## VARGA TRAFFIC PLANNING Pty Ltd

### DA-2016/420 PROPOSED MIXED USE DEVELOPMENT 395-397 Princes Highway, Rockdale TRAFFIC AND PARKING MATTERS

## Response to Council's Parking and Traffic Comments dated 9 December 2016

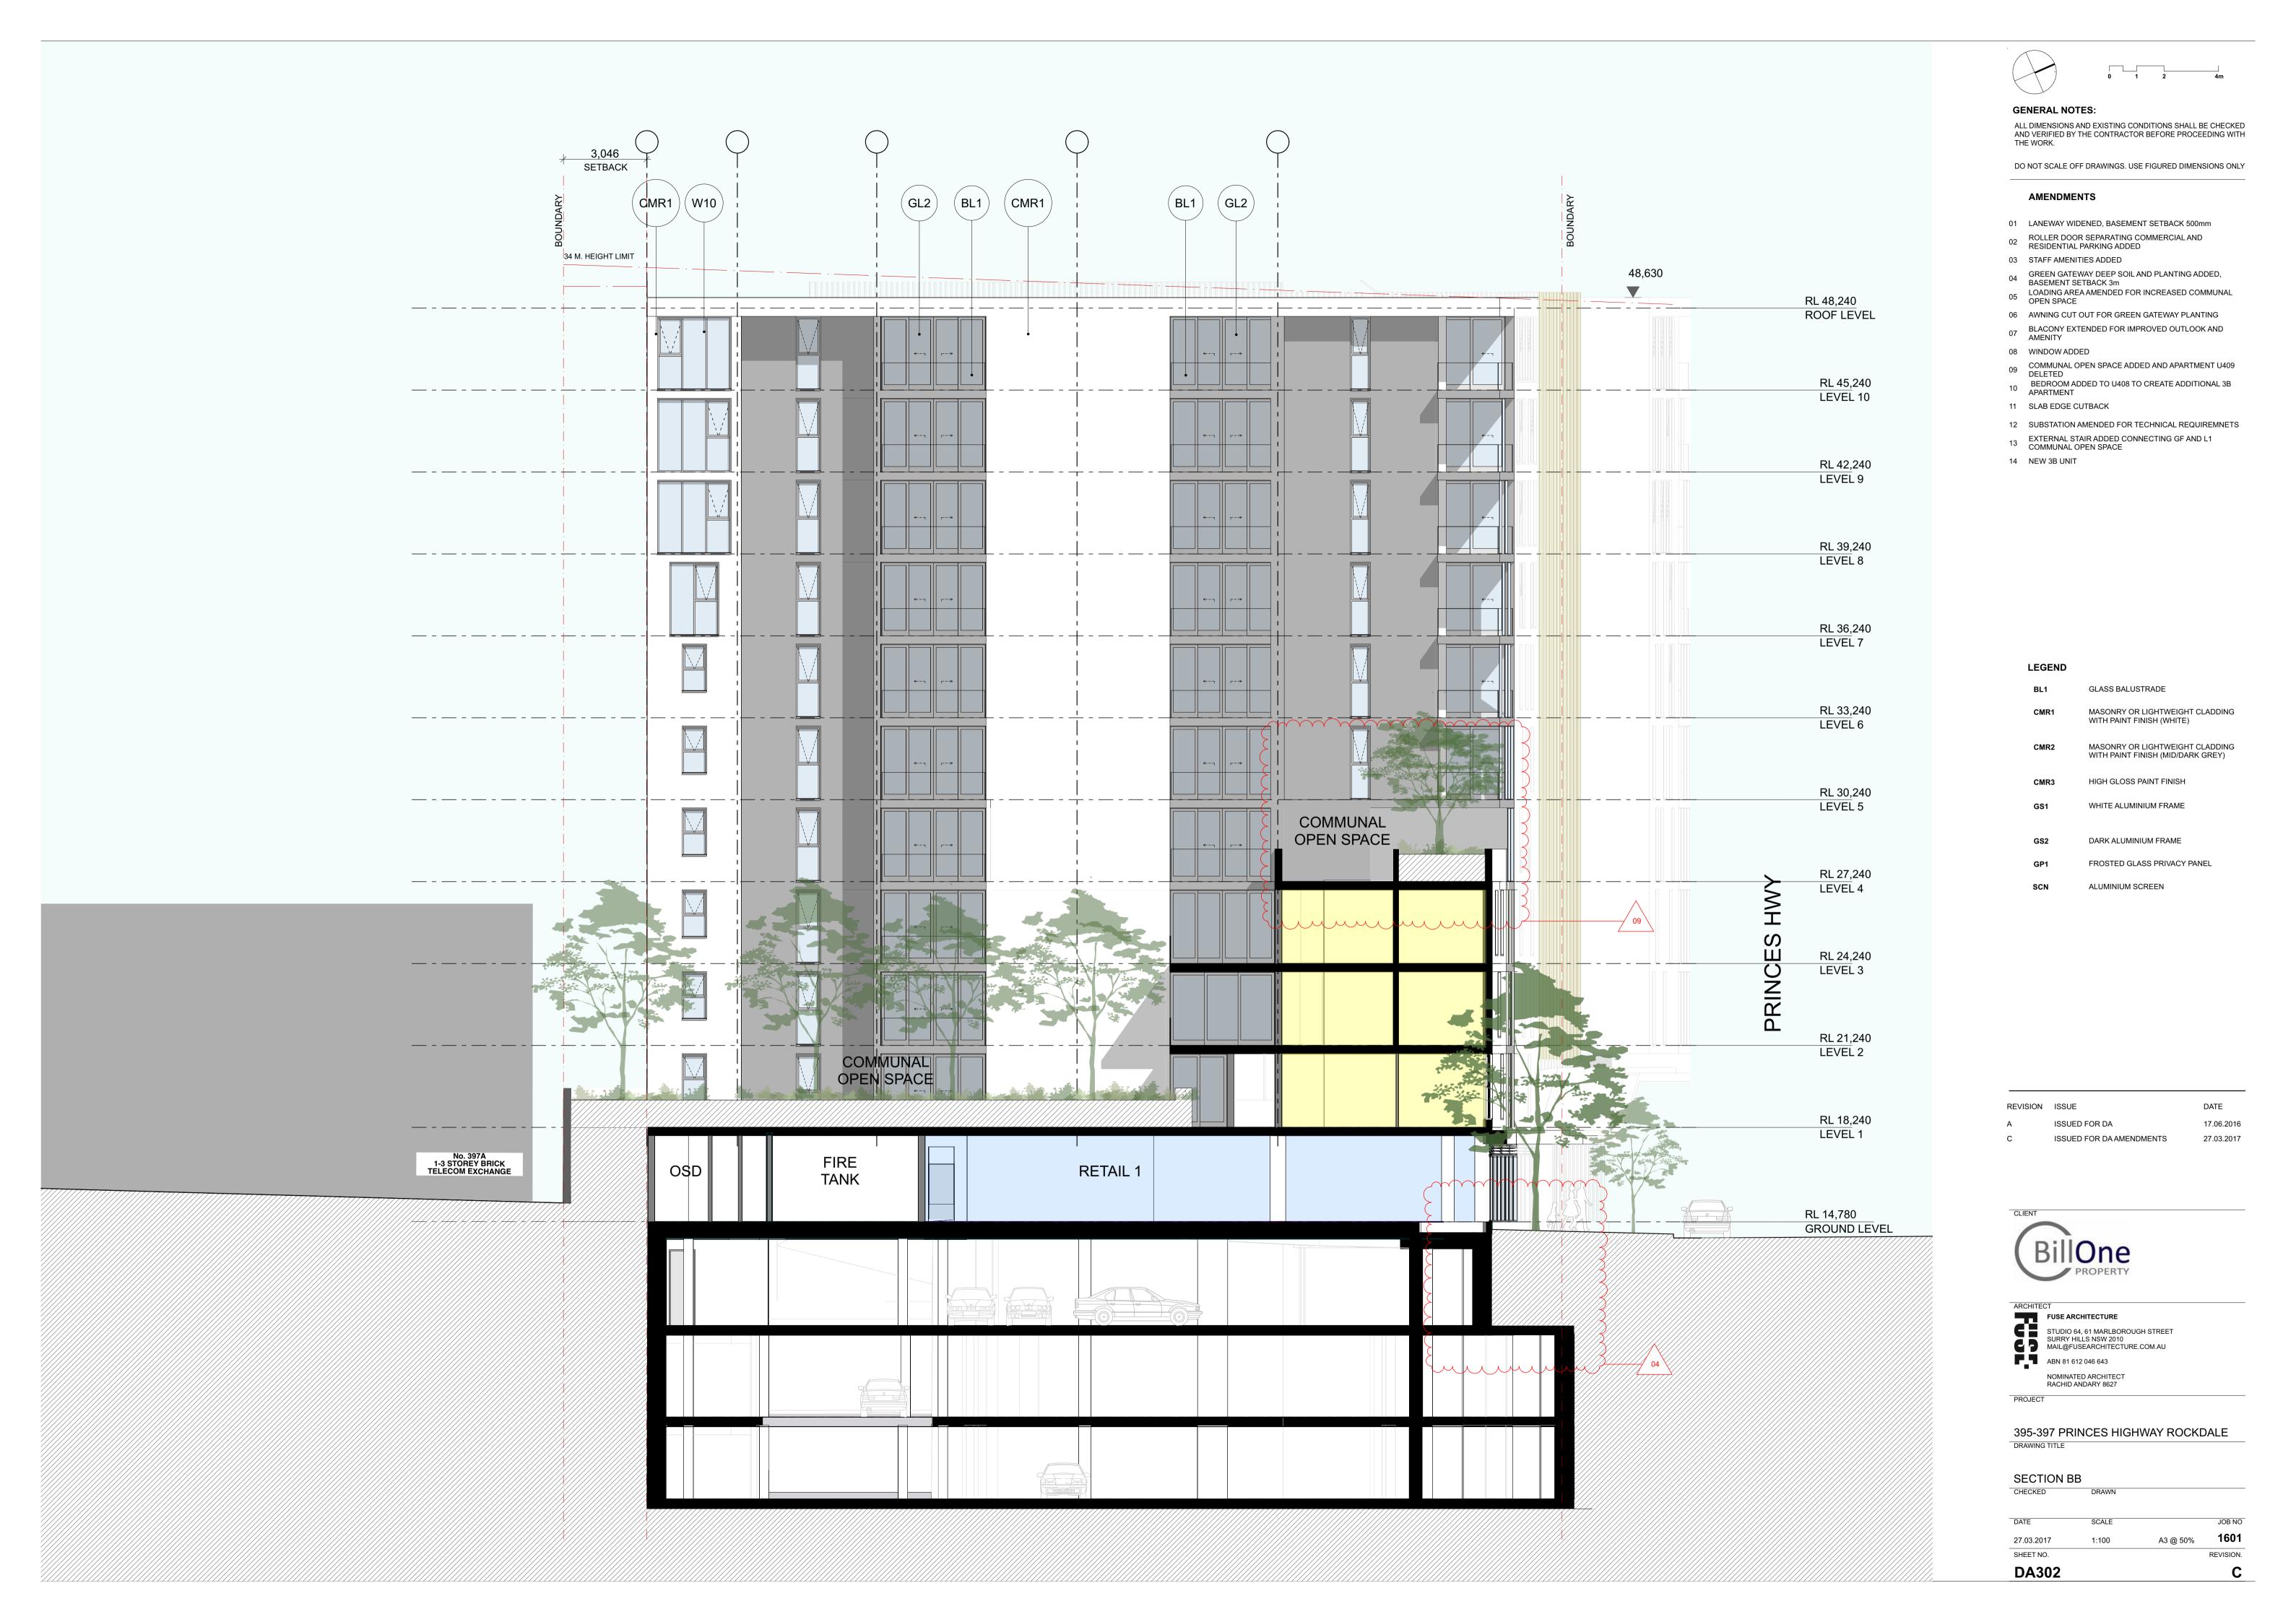
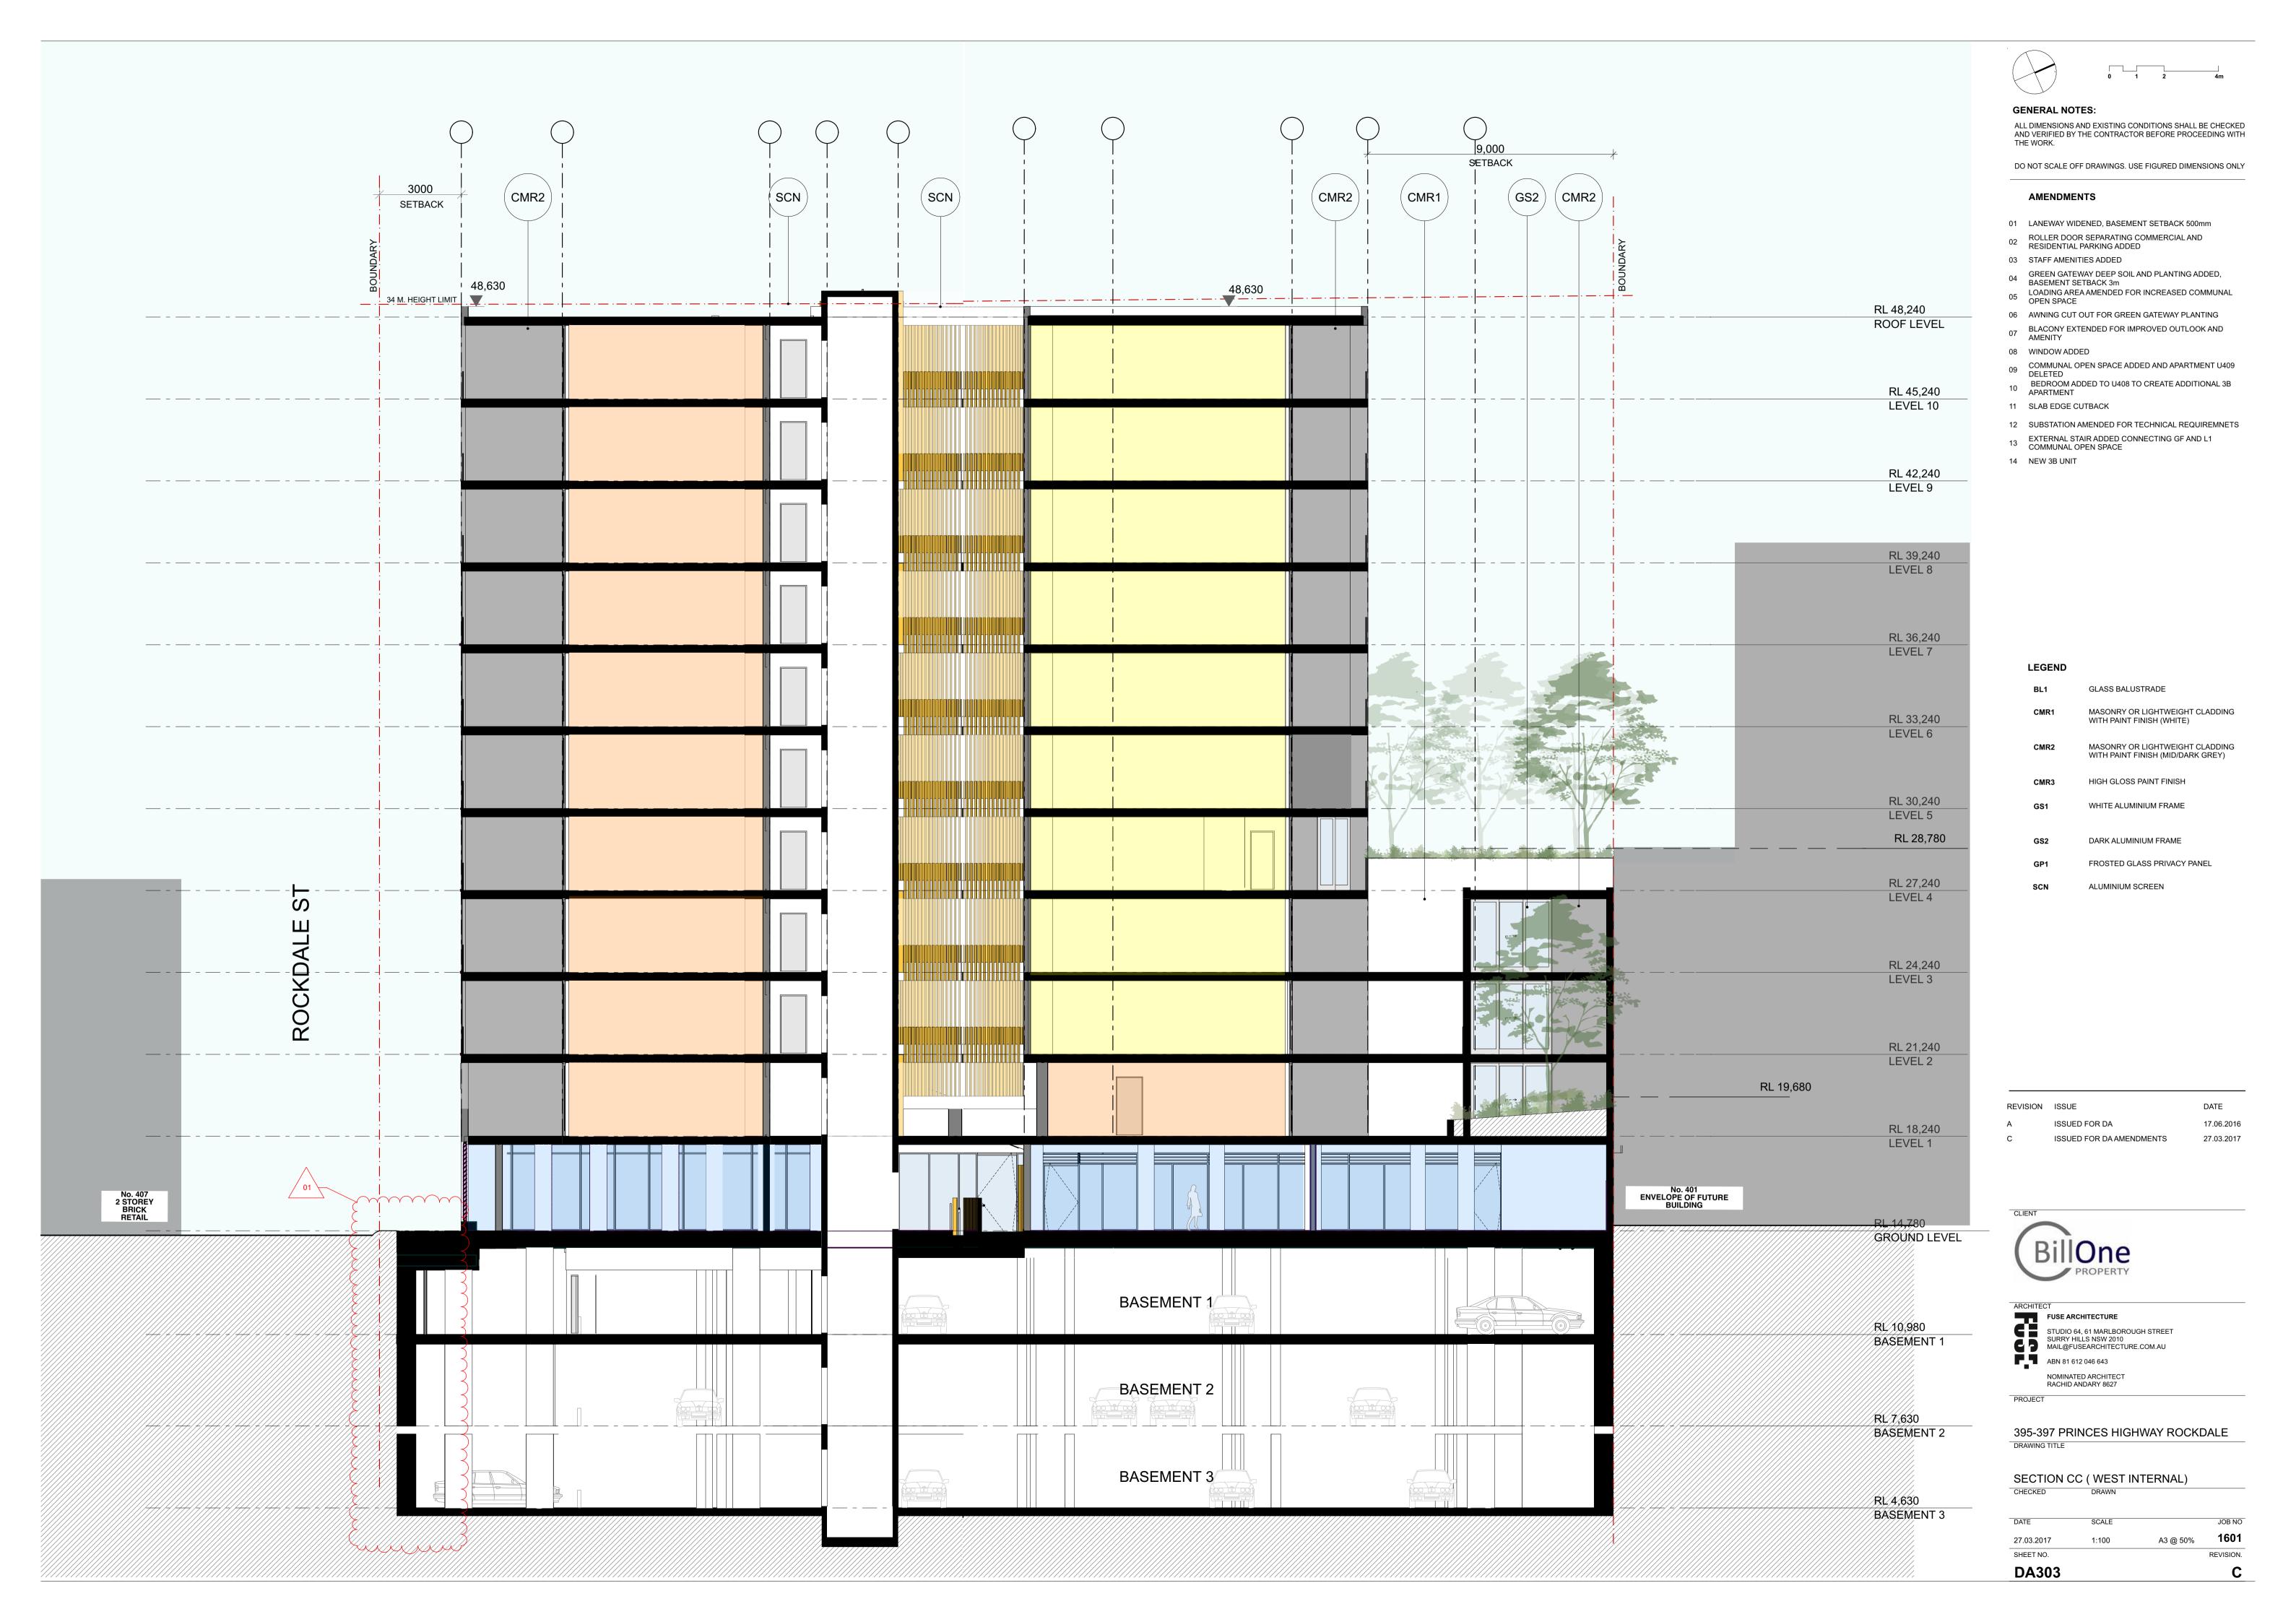
- 01 LANEWAY WIDENED, BASEMENT SETBACK 500mm
- ROLLER DOOR SEPARATING COMMERCIAL AND

- 06 AWNING CUT OUT FOR GREEN GATEWAY PLANTING

- 12 SUBSTATION AMENDED FOR TECHNICAL REQUIREMNETS
- 13 EXTERNAL STAIR ADDED CONNECTING GF AND L1 COMMUNAL OPEN SPACE

- GREEN GATEWAY DEEP SOIL AND PLANTING ADDED,
- LOADING AREA AMENDED FOR INCREASED COMMUNAL
- BLACONY EXTENDED FOR IMPROVED OUTLOOK AND
- COMMUNAL OPEN SPACE ADDED AND APARTMENT U409
